APPEAL RECOMMENDATION REPORT

Case No.: DIR-2017-5367-DB-CDO-1A
CEQA No.: ENV-2017-5368-CE
Related Cases: None
Council No.: 13 – O’Farrell
Plan Area: Silver Lake – Echo Park – Elysian Valley
Specific Plan: None
Certified NC: Echo Park
GPLU: Low Medium II Residential
Zone: RD2-1VL-CDO
Applicant: Daniel Pourbaba
Representative: Todd Elliott
Truman & Elliott LLP
Appellant(s): Cody Briggs, Montrose
Condos Homeowner’s
Association

PROJECT LOCATION: 923-929 Glendale Boulevard, 1810 West Montrose Street

PROPOSED PROJECT: The construction, use, and maintenance of a new 15-unit multi-family apartment building with one level of subterranean parking in the RD2-1VL-CDO Zone. This project provides one (1) on-site restricted affordable dwelling unit for Very Low-Income Household Occupancy.

Figure 1: Protected Smaller California Black Walnut

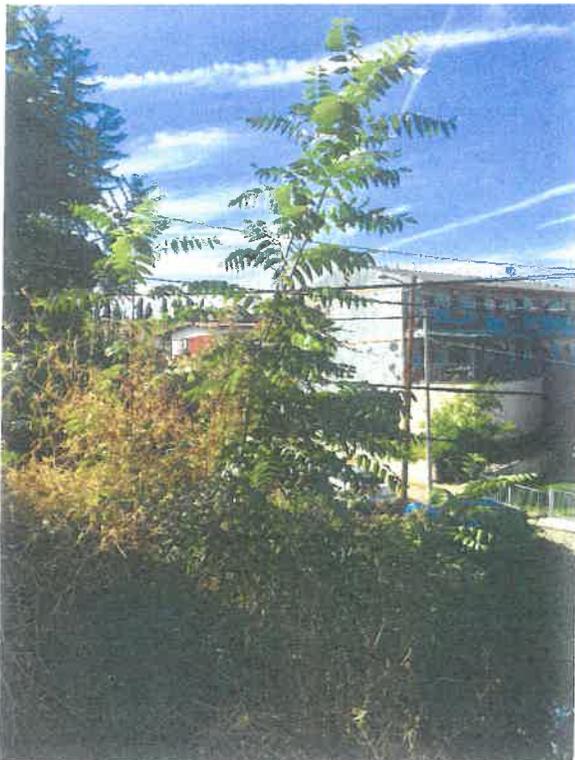
The proposed development project parcels has two *Juglans californica*, commonly known as Californian Black Walnut Trees. One is located in the north-westerly corner and approximately has a diameter of 8" and is 12' tall (See Figure 1 and 2) and the other tree is near the westerly property line and approximately has a diameter of 7', a height of 40', and a canopy of 60' (See Figures 3 and 4). Both trees meet the requirements to be considered a Protected Tree. The Los Angeles County Significant Ecological Areas Program says the Californian Black Walnut "is an endangered tree species due to the loss of habitat from development, overgrazing, and increased recreational use of walnut woodlands"

The proposed development will take place on a parcel with two California Black Walnut which are identified as a protected tree by City of Los Angeles Ordinance 177404. The protection of these trees should be included as a condition of approval for the proposed development and was not included in the Director's Determination.

Density Bonus/Affordable Housing Incentives Compliance Findings of Categorical Exemption c (*The project site has no value as habitat for endangered, rare, or threatened species*) should be modified now that evidence has been submitted (and was previously submitted via email to the planchecker on 4/17/18) of the existence of endangered and protected Californian Black Walnut Trees.

Staff Response: The initial filing did not include information about the existing trees. After an appeal was filed, the applicant provided a tree report, from Mr. Paul Lewis, Landscape Architect, who found one Juglans Californica (Black Walnut) tree is in fact on the site, and three non-protected trees. All trees are proposed to be removed. The removal of the protected tree will require a permit and review by the Urban Forestry Division of the Bureau of Street Services. The removal of the protected tree will require replacement at a four to one ratio. In addition, the Project will be required to provide additional trees per LAMC Section 12.21G at a ratio of one tree for every four dwelling units proposed.

Therefore, a technical modification is included as part of this appeal report and the amended landscape plans were submitted to demonstrate compliance with the replacement requirements for protected trees and LAMC Section 12.21G.
